PROPOSED S4.56 MODIFICATIONS LIST:

S4.56 MODIFICATIONS

9-11 VICTORIA PARADE, MANLY, NSW

SOUTHWEST ELEVATION

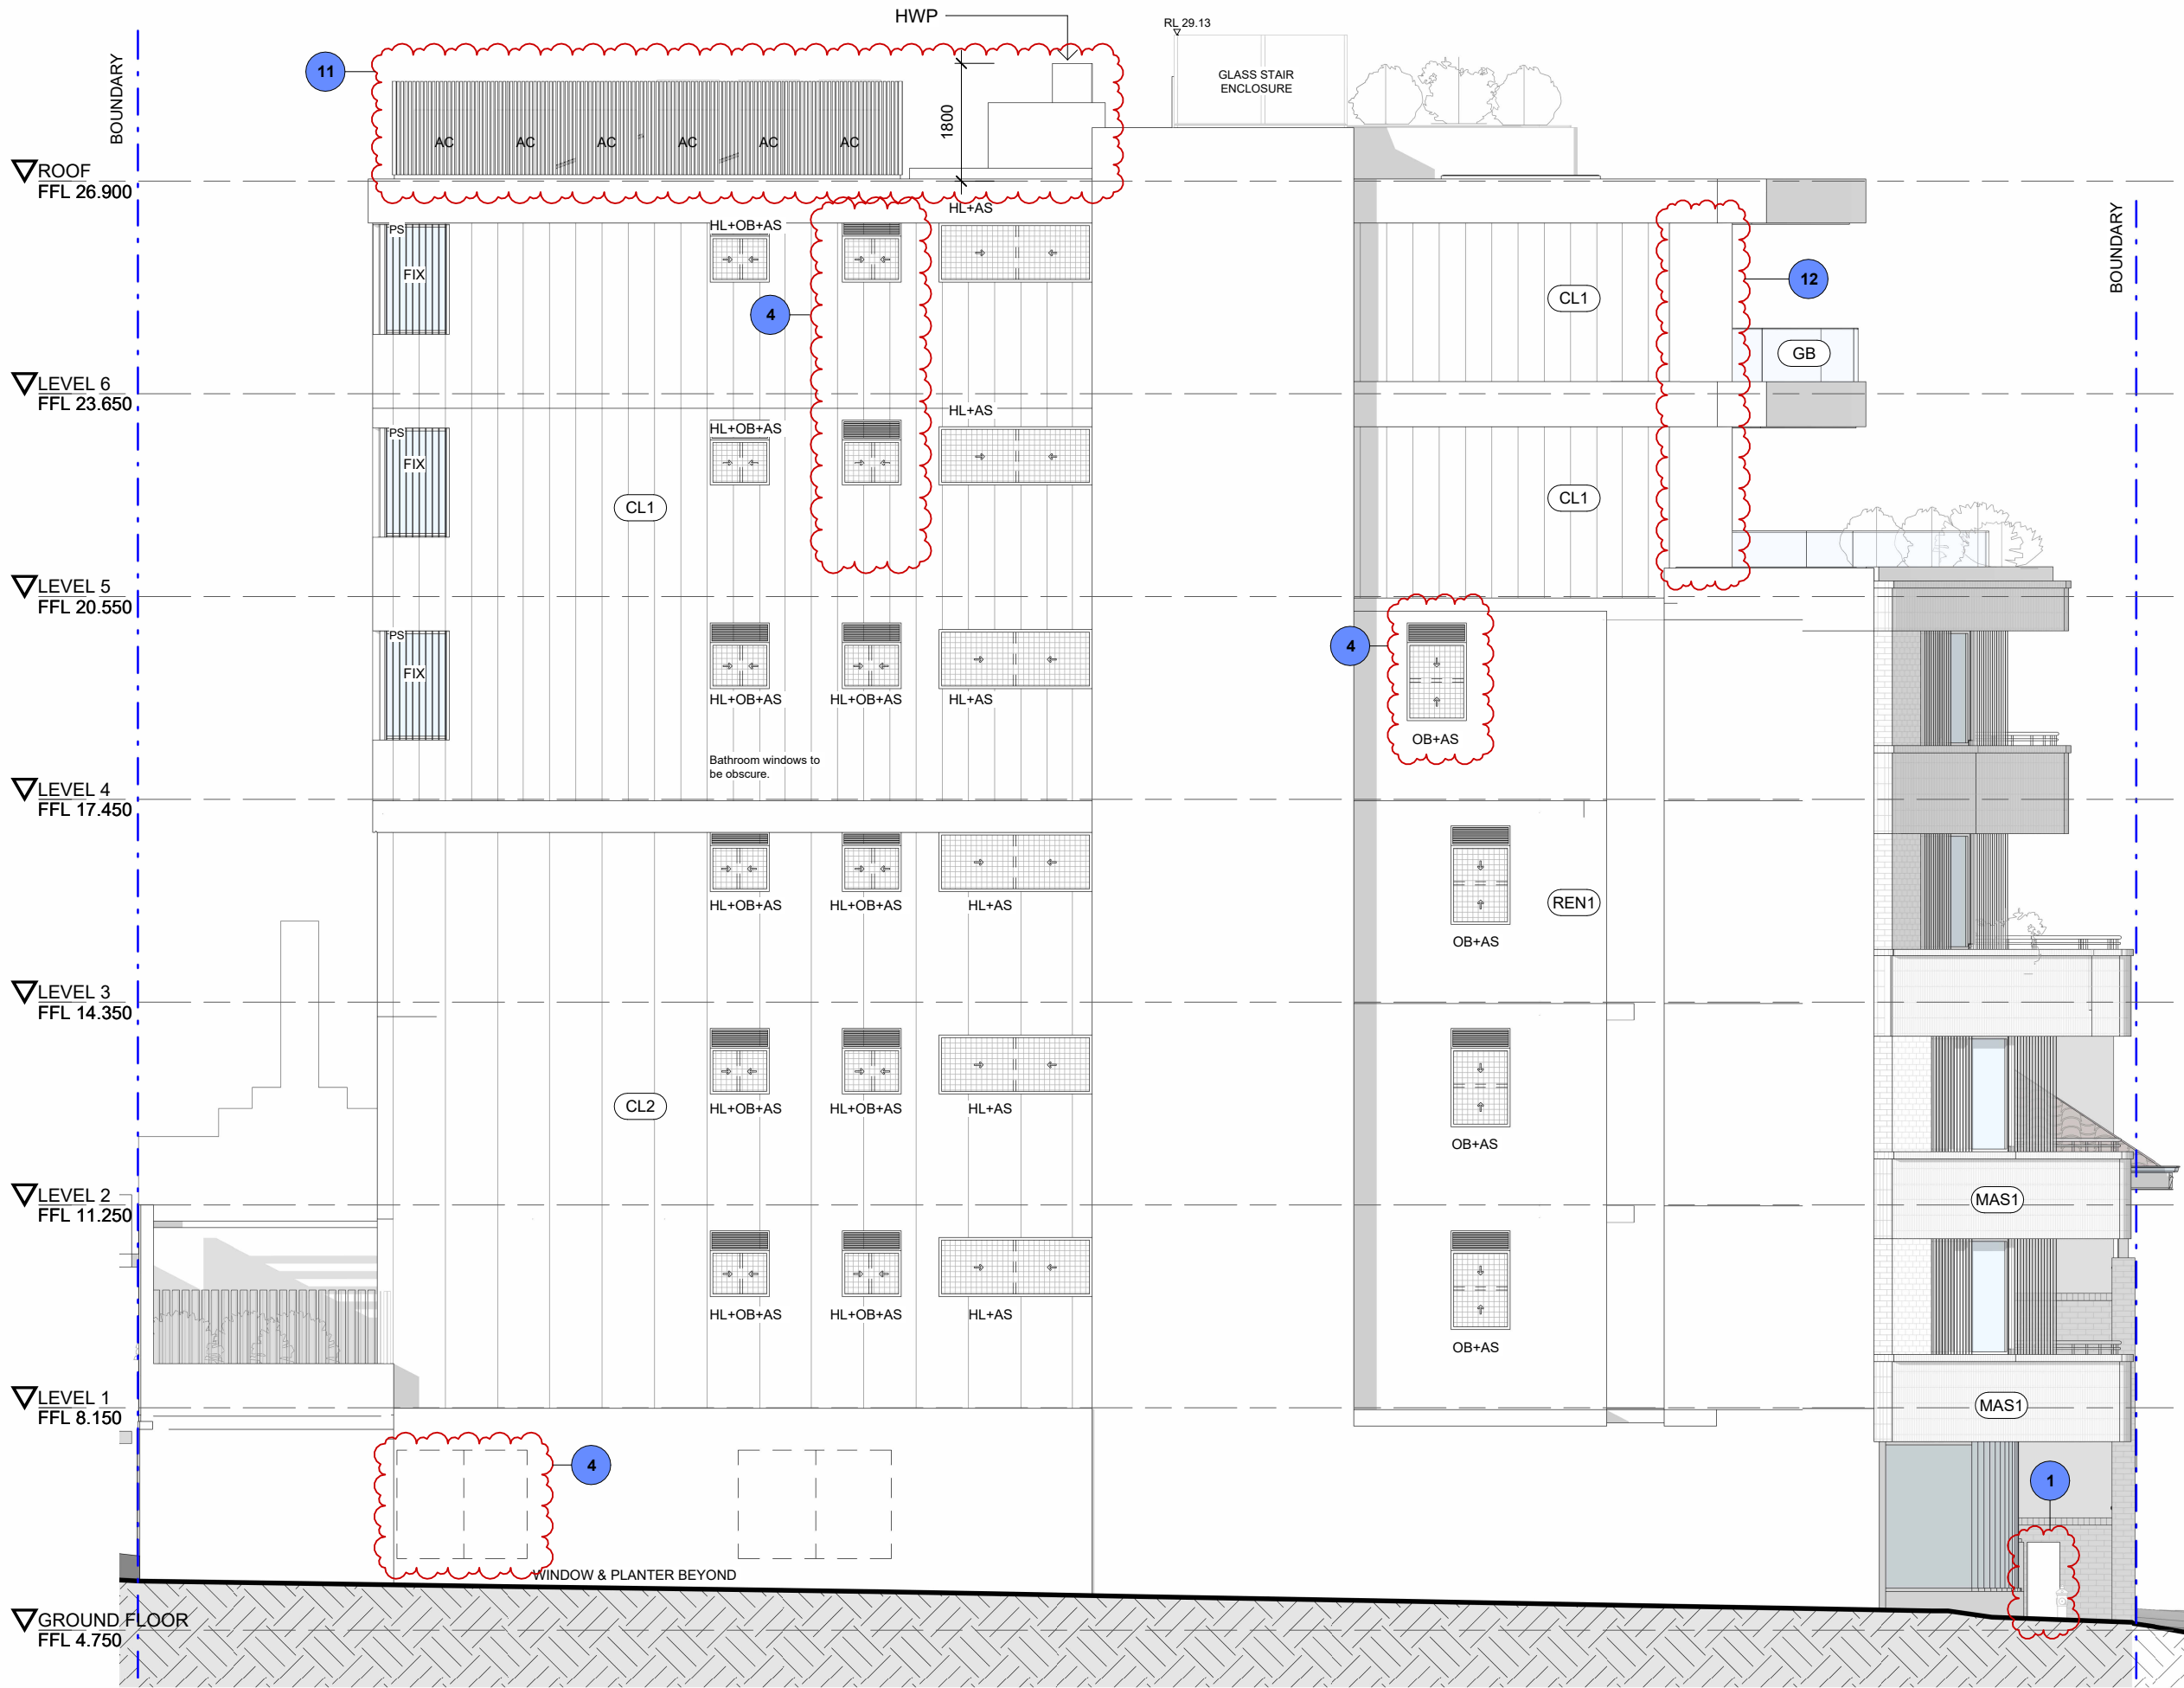
1. Revised fire hydrant booster location
2. Revised internal layouts and associated services and structure.
3. Amalgamation of Units 10 & 11 on Level 4 to a single SOU.
4. Revised window size and location in response to revised layouts.
5. BBQ added to terraces
6. Skylights added
7. Revised Core position and related walls
8. Revised landscaping area
9. Revised fire stairs
10. Revised storage cages
11. Added HWP and moved AC units
12. Addition of blade wall
13. Addition of Photovoltaic Panels
14. Proposed enclosure of parking spaces into private garages.

NORTHWEST ELEVATION

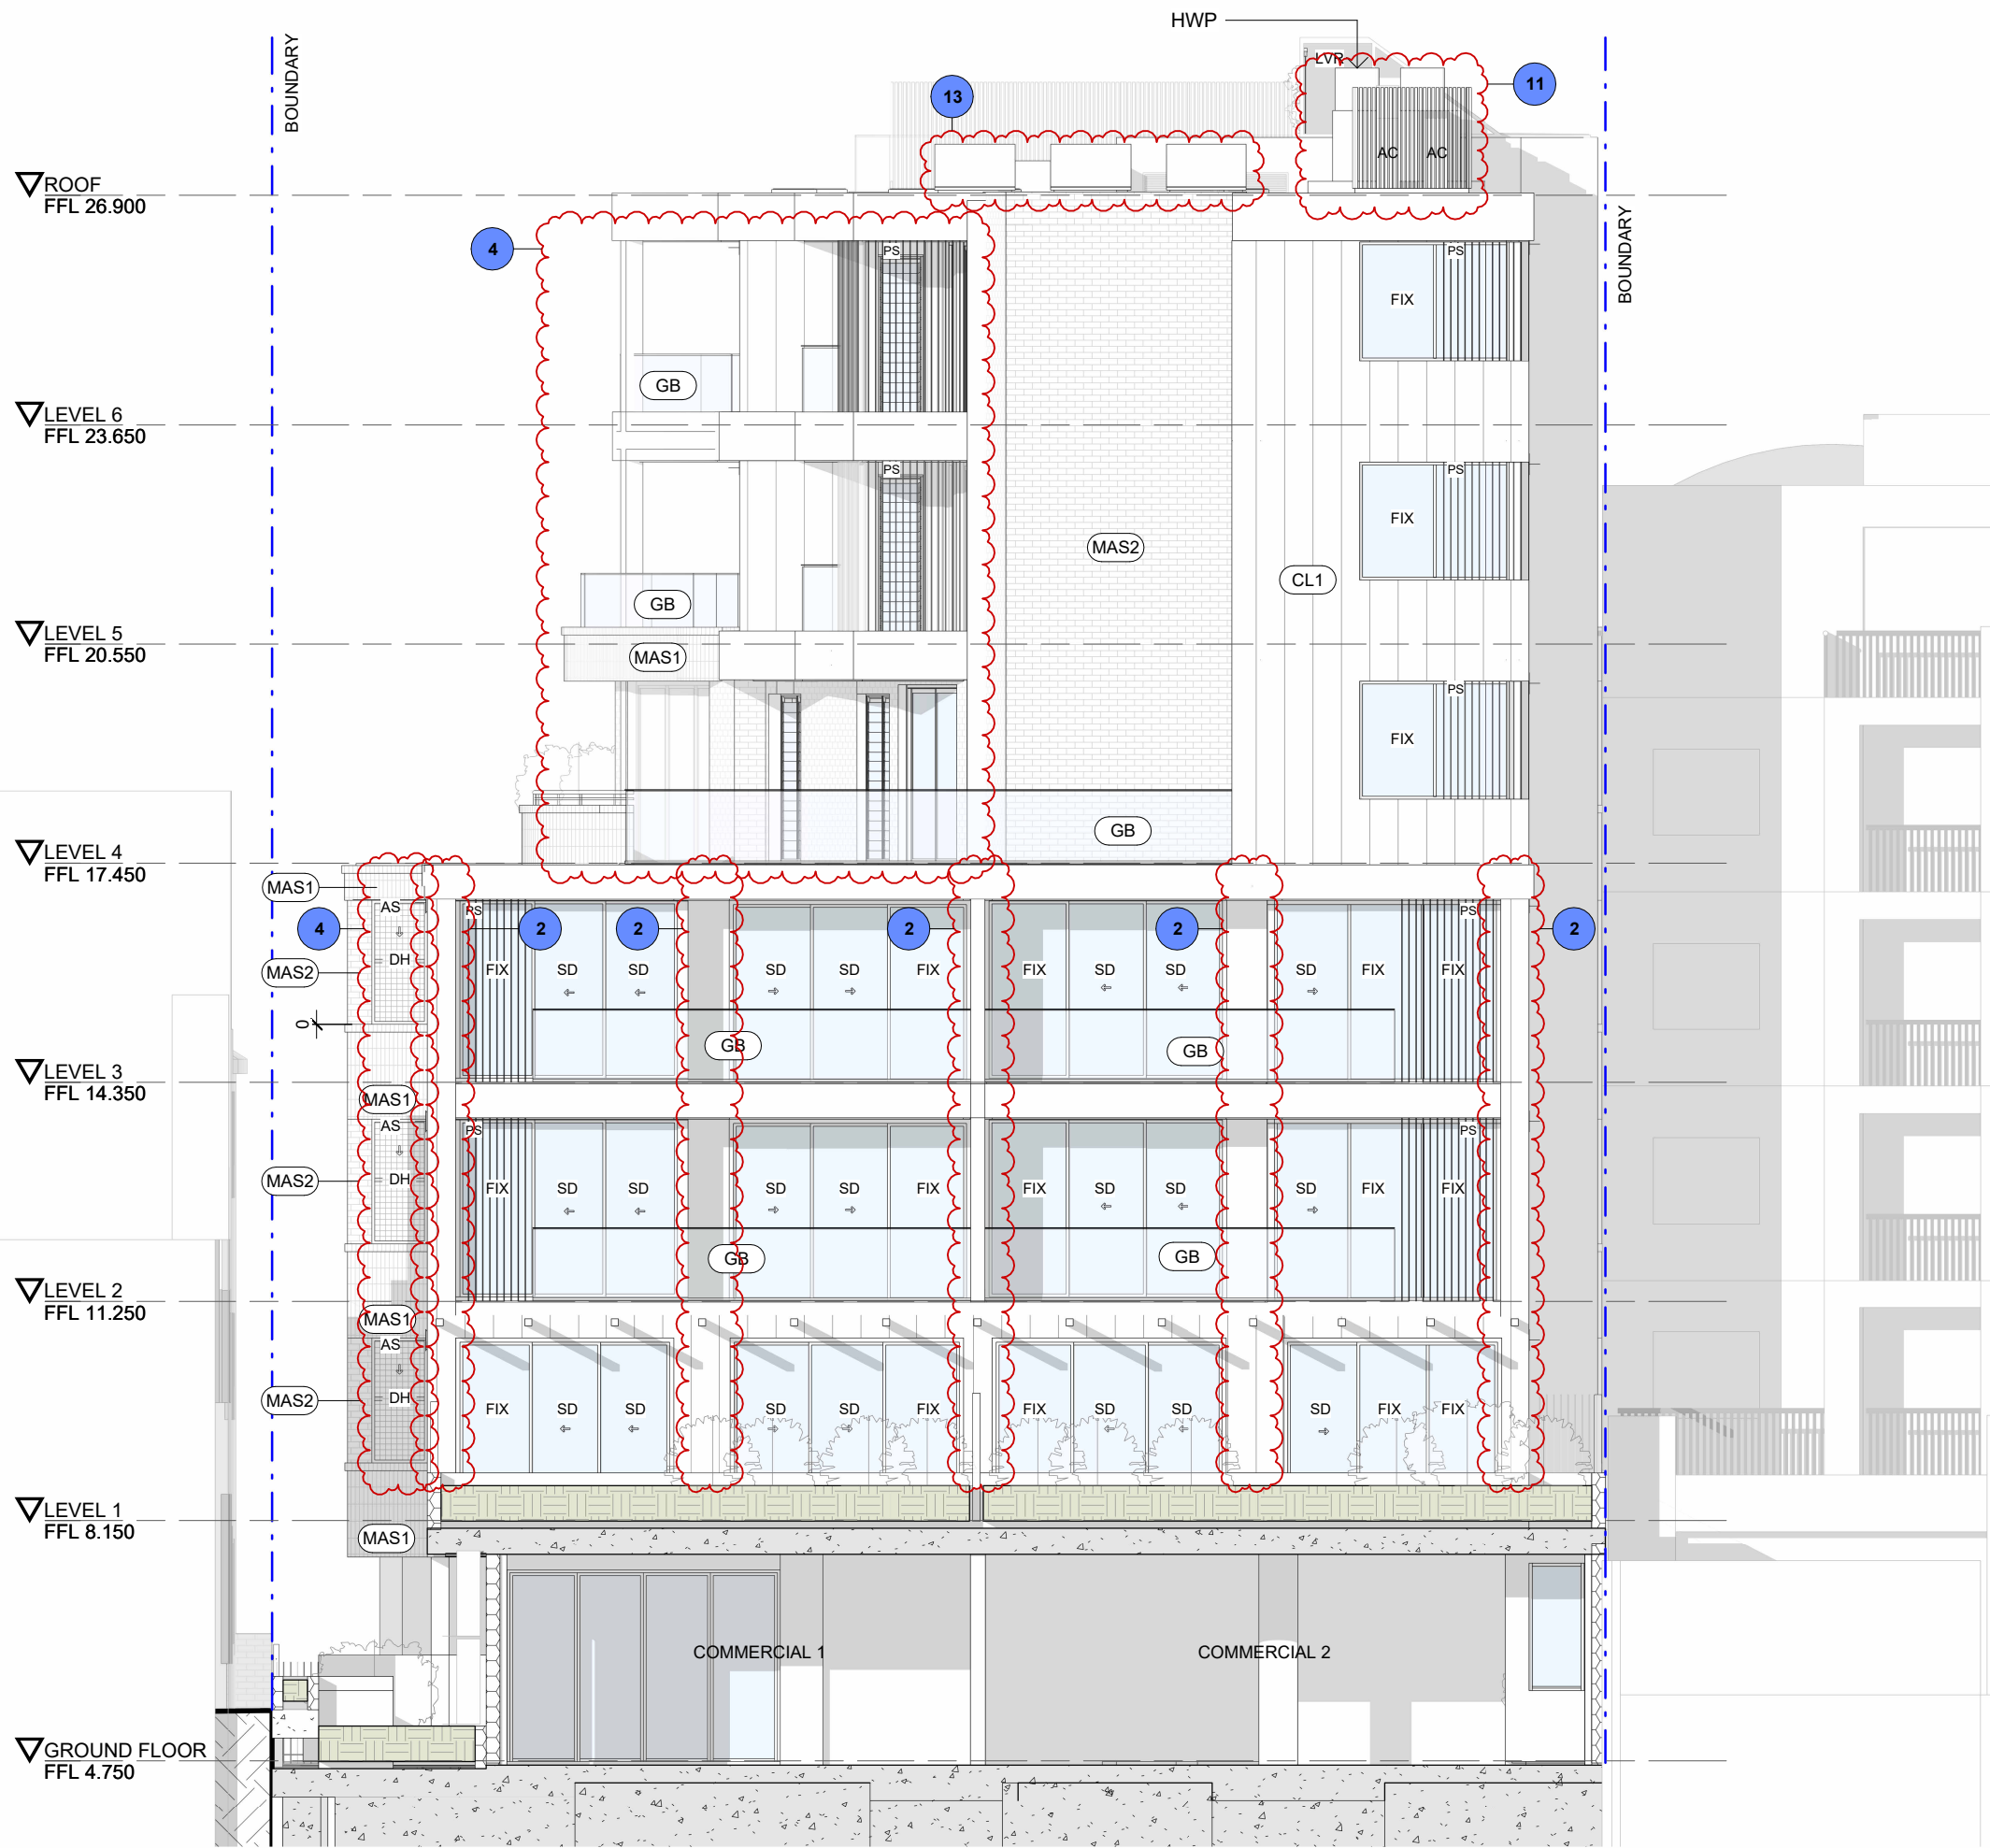
1. Revised fire hydrant booster location
2. Revised internal layouts and associated services and structure.
3. Amalgamation of Units 10 & 11 on Level 4 to a single SOU.
4. Revised window size and location in response to revised layouts.
5. BBQ added to terraces
6. Skylights added
7. Revised Core position and related walls
8. Revised landscaping area
9. Revised fire stairs
10. Revised storage cages
11. Added HWP and moved AC units
12. Addition of blade wall
13. Addition of Photovoltaic Panels
14. Proposed enclosure of parking spaces into private garages.
